NGDV – Technical Bulletin

Title: Oshkosh Diagnostic Tool (OKDT) Release 04/08/2026	
Number: NGDVTB015	Revision: A
Classification: Highly Restricted

Oshkosh Diagnostic Tool (OKDT) Release Note

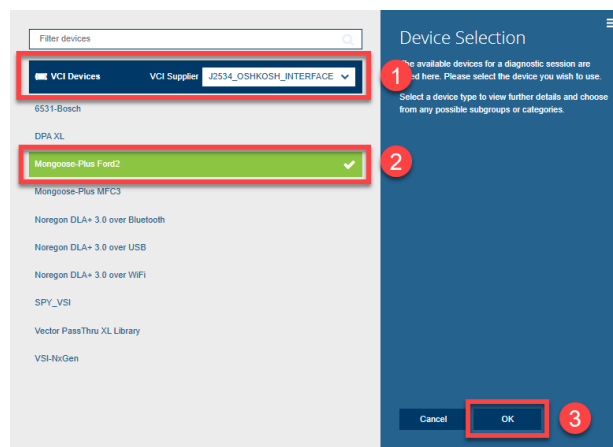
The VCI user interface change will require all users to re-select their VCI from the menu. This is a one time selection only. Users will see the Start with Automatic Identification and Start by VIN Entry (1) and No device selected (2) options greyed out on the Quick Start menu.

User will need to select the Change (3) button in order to reselect their VCI.

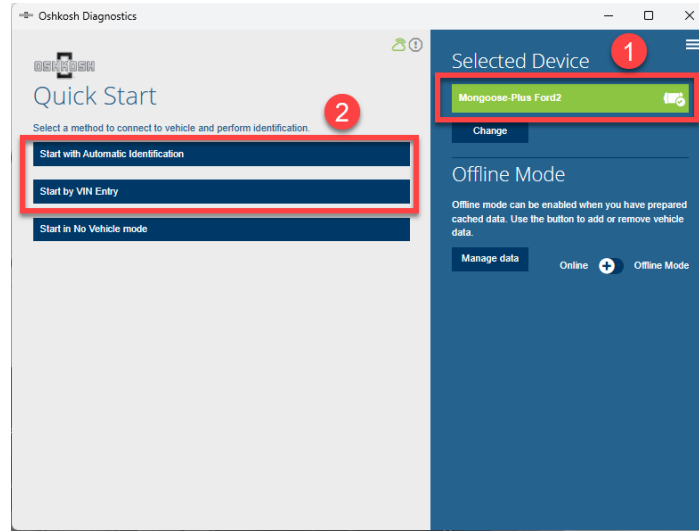
On the device selection screen, verify the J2534_OSHKOSH_INTERFACE is selected as the VCI Supplier (1), select your specific VCI from the options available (2), then select OK.

Addition of DCDC Voltage Datalogger Data Identifier (DID) - (Information only – No User Action Required)

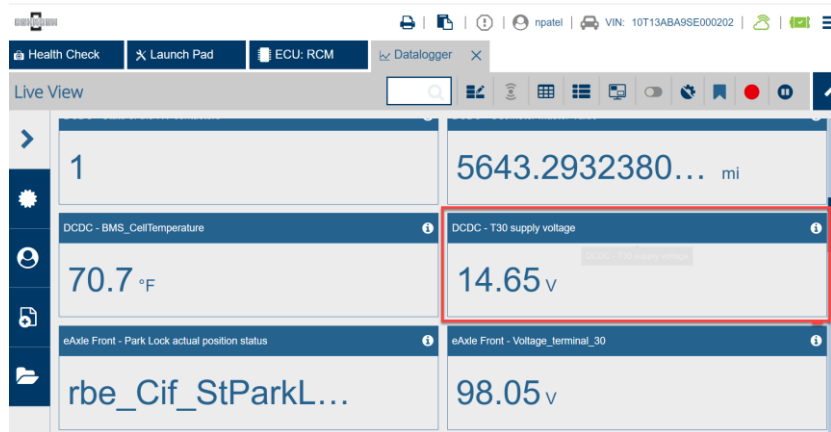
DCDC supply voltage DID has been added to the Datalogger → BEV list
